4-17. IMPACT ON BOX GUM WOODLAND

Concern:

The White Box-Yellow Box-Blakely's Red Gum Grassy Woodland is listed as critically endangered. The EIS does not clearly explain how groundwater drawdown from the proposed Project will impact these protected woodlands outside the mine site.

Figure 1: Drop in water table 50 years post mining in metres, showing potential GDE areas shaded in blue. Source: Adapted from Figure 73 from Jacobs (2020) p5-173

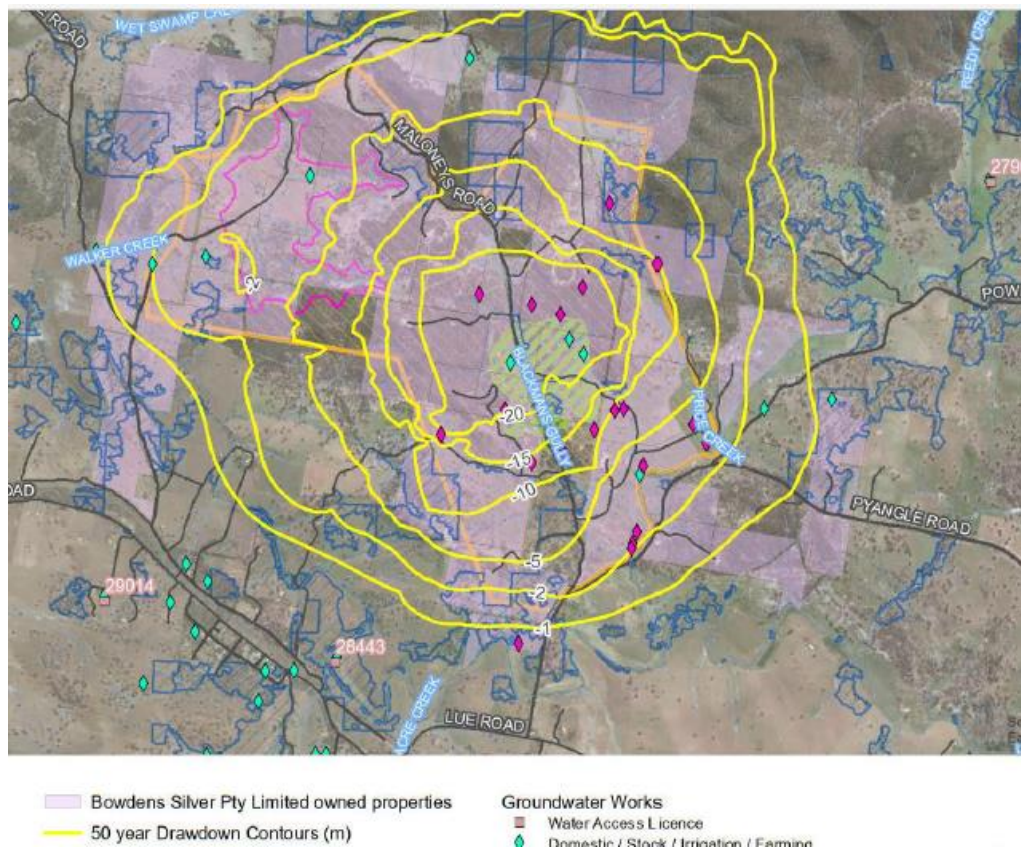
The White Box-Yellow Box-Blakely's Red Gum Grassy Woodland and Derived Native Grassland is listed as critically endangered. Root systems extract groundwater that is subsequently transpired. The evapo-transpiration 'extinction' depth is set at 3 m (Jacobs (Australia), 2020, pp. 5-141). This means that shallower than 3 m depth, moisture in the soil is able to be accessed for transpiration. Figure 73 of Jacobs (2020) (Figure 1) indicates a lowering of the water table outside the mine site by around 2 km. The impact of a decrease in shallow groundwater availability in these areas is not explicitly covered in the EIS. Groundwater levels can be shallow around the alluvium near BGW01, BGW03, BGW04, BGW05 and BGW06. Based on the drawdown predictions, drawdown beneath the white Box-Yellow Box-Blakely's Red Gum Grassy Woodland and Derived Native Grassland is expected to be up to 10 m outside the mine site 50 years post mining (Jacobs (Australia), 2020, pp. 5-173). Given the endangered nature of these communities, the potential impacts of drawdown should be adequately assessed.

Figure 3: NSW Hydrograph showing natural inter-seasonal variability

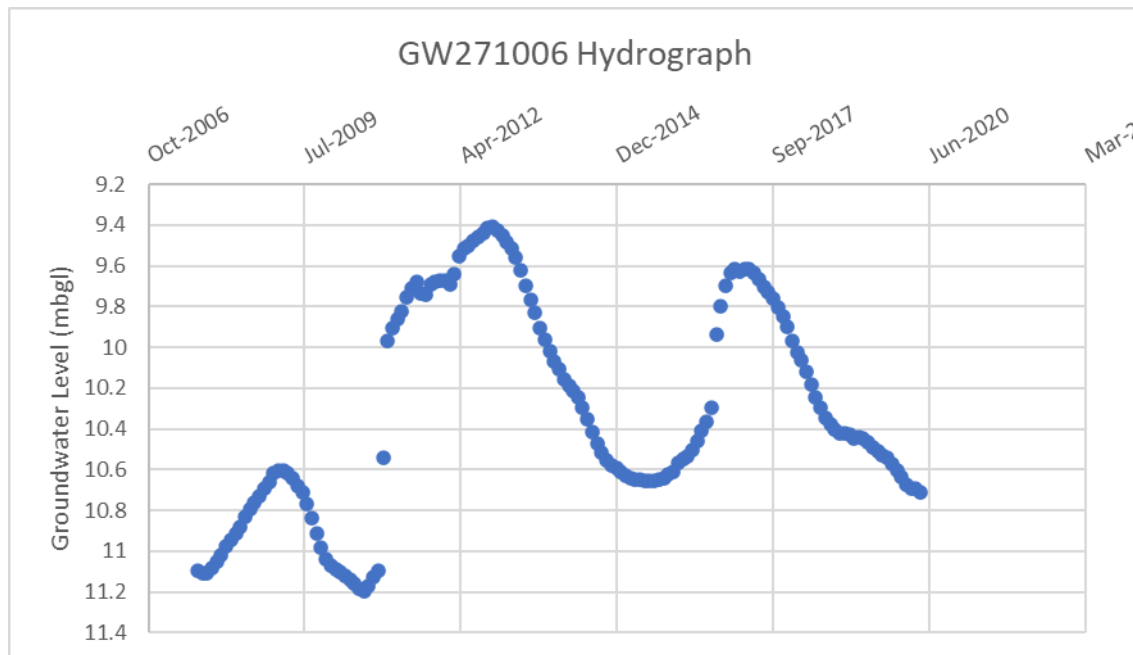
If significant ecosystems cannot access water during times of water scarcity, their health may be temporarily or permanently impacted. Inter-seasonal groundwater level changes in the region are measured at state monitoring bore GW271006 located 18 km northeast of the site. While groundwater is deeper at GW271006 than at BGW56 and BGW31 around Lue, the hydrograph (Figure 3) shows an inter-seasonal variability of up to 1 m. Hydrographs presented in the EIS feature periodic data gaps and the seasonality of groundwater levels near the mine site is not evident in the data presented nor in the discussion of results. Impacts from the proposed mine will be cumulative to these existing groundwater level changes.
